SERVICE / INSPECTION REPORT

Address, Edwards, Colorado 81632

12/05/2025

Fireplace in the Pool House Living Room

Fireplace in the Pool House Living Room - HEARTH EXTENSION

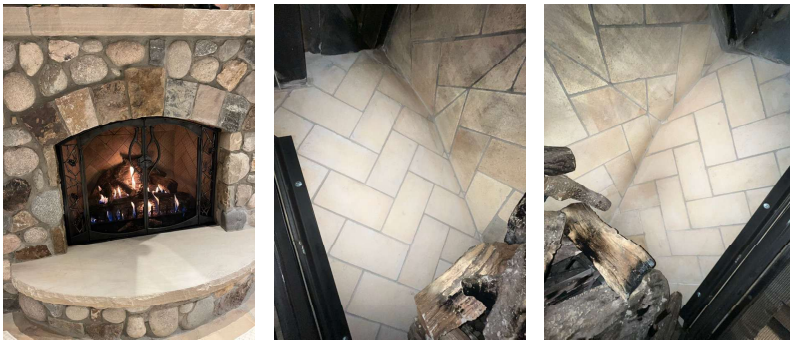
As this is a mostly exterior structure with a basement below, the hearth extension is not fully supported by masonry and must have combustible flooring materials beneath.

Hearth Extension: Improper construction, Combustibles beneath masonry hearth extension

Technician Recommendations: It is recommended that the system NOT be used and is either repaired or replaced. Inserts and gas logs sets both rely on the original masonry system to meet minimum safety standards, which are not met, and should not be used.

A viable repair option may include a Retro-Fit Masonry Fireplace with a stainless steel liner, which would negate clearance requirements.

Replacement options include a Modular Masonry System and a Factory-Built Fireplace. Each of these systems have their own testing and listing requirements which would negate the present clearance issues within the existing system. Depending on the desired replacement option, invasiveness will vary.

Fireplace in the Pool House Living Room - FIREPLACE/APPLIANCE CONCEALED IN CONSTRUCTION

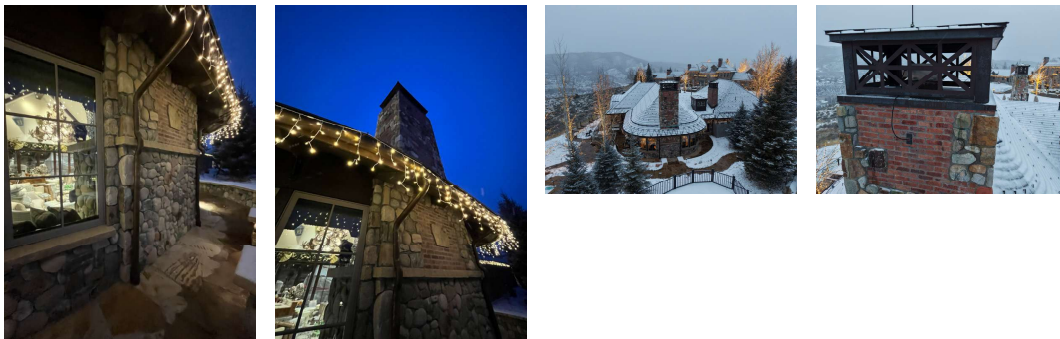
Masonry Fireplace/SFU Concealed in Construction: Clearances NOT met

Fireplace in the Pool House Living Room - CHASE OR MASONRY STRUCTURE EXTERIOR

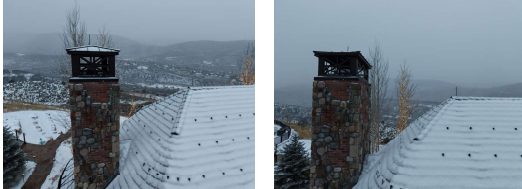
Chase or Masonry Structure Exterior: Other Issue

Fireplace in the Pool House Living Room - CHIMNEY, VENT, OR FLUE INTERIOR

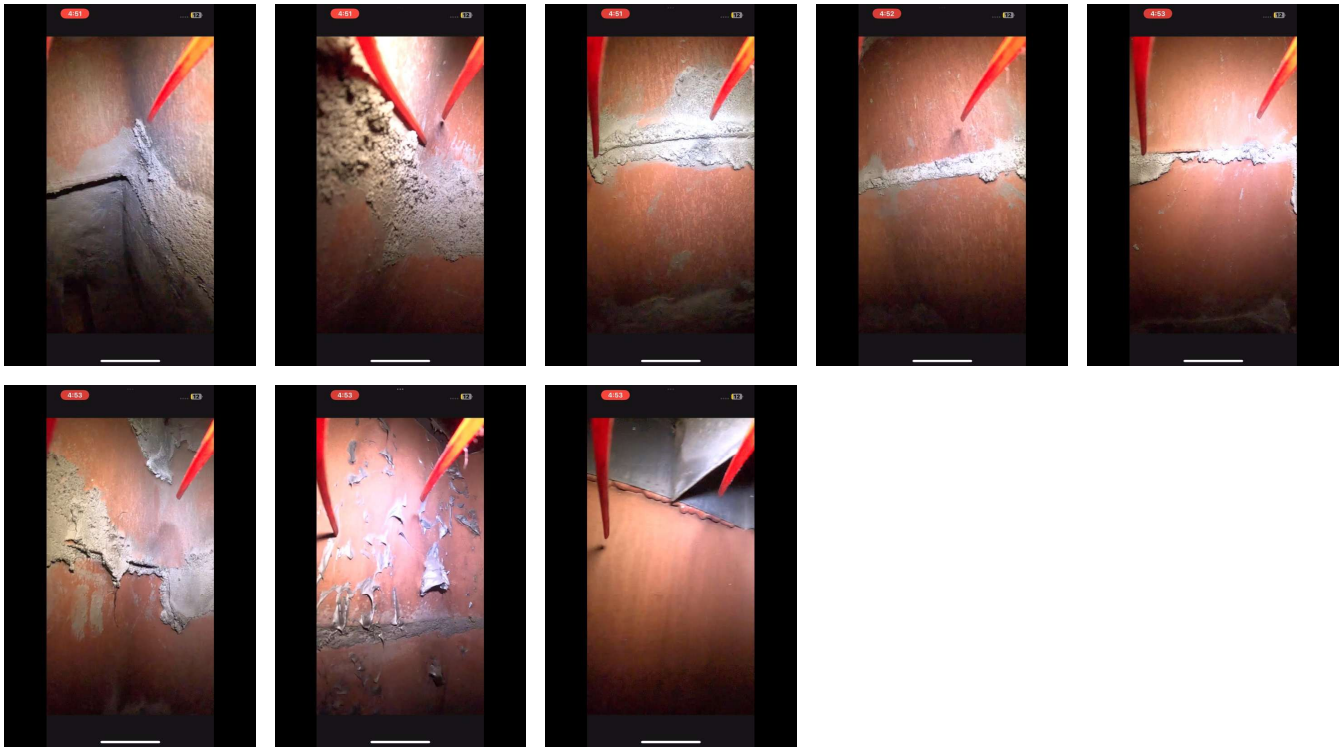
Masonry Chimney/Flue Interior: Excess mortar at liner joints, Other Issue

Fireplace in the Pool House Grey Room - CHIMNEY, VENT, OR FLUE INTERIOR

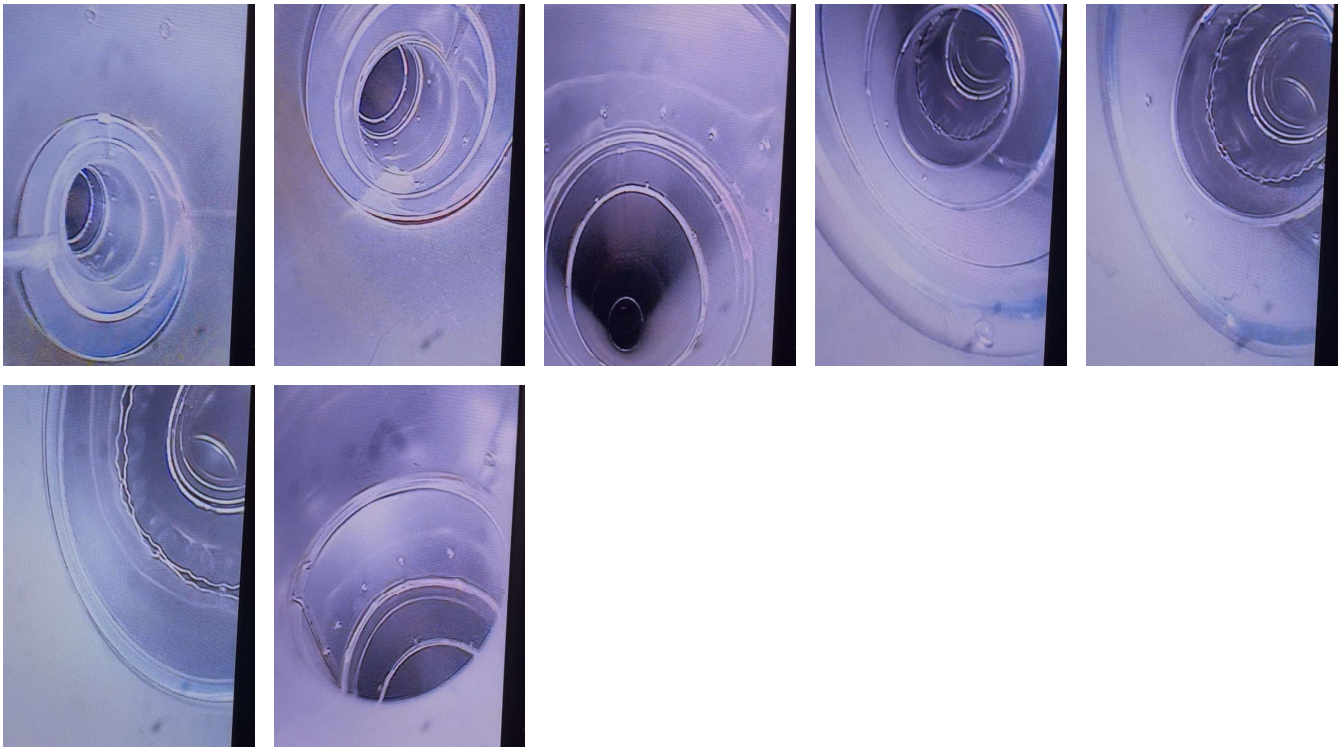
Factory-Built Chimney, Vent, or Flue Interior: Other Issue

Technician Recommendations: It is recommended that the system NOT be used until proper repairs are made. This would include reconstructing the facing material to meet the manufacturer's recessed depth requirement, securing/removing the insulation from the chase cavity and replacing the damaged section of venting as well as any venting damaged in accessing it.

Fireplace in the Pool House Pink Room - CHIMNEY, VENT, OR FLUE INTERIOR

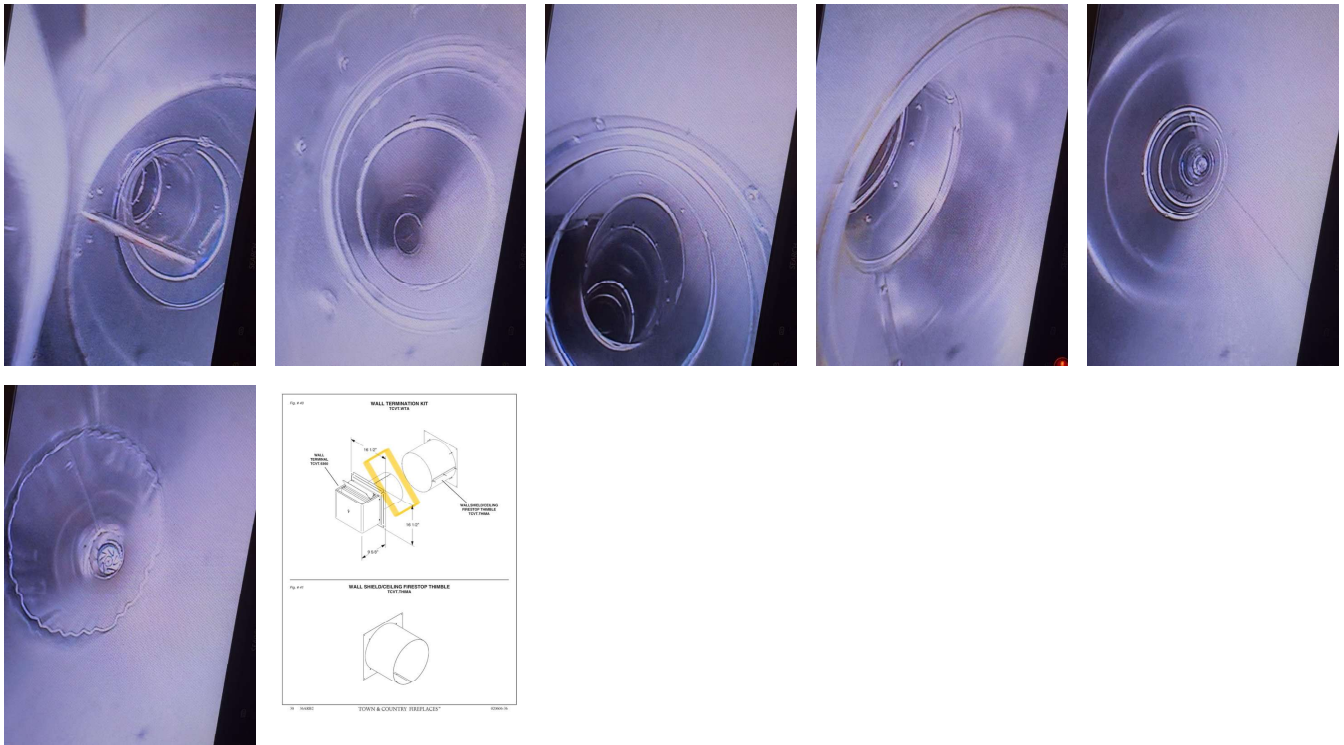
Factory-Built Chimney, Vent, or Flue Interior: Other Issue

Technician Recommendations: It is recommended that the system NOT be used until proper repairs are made. This would include reconstructing the facing material to meet the manufacturer's recessed depth requirement and replacing the damaged venting as well as any venting damaged in accessing it.
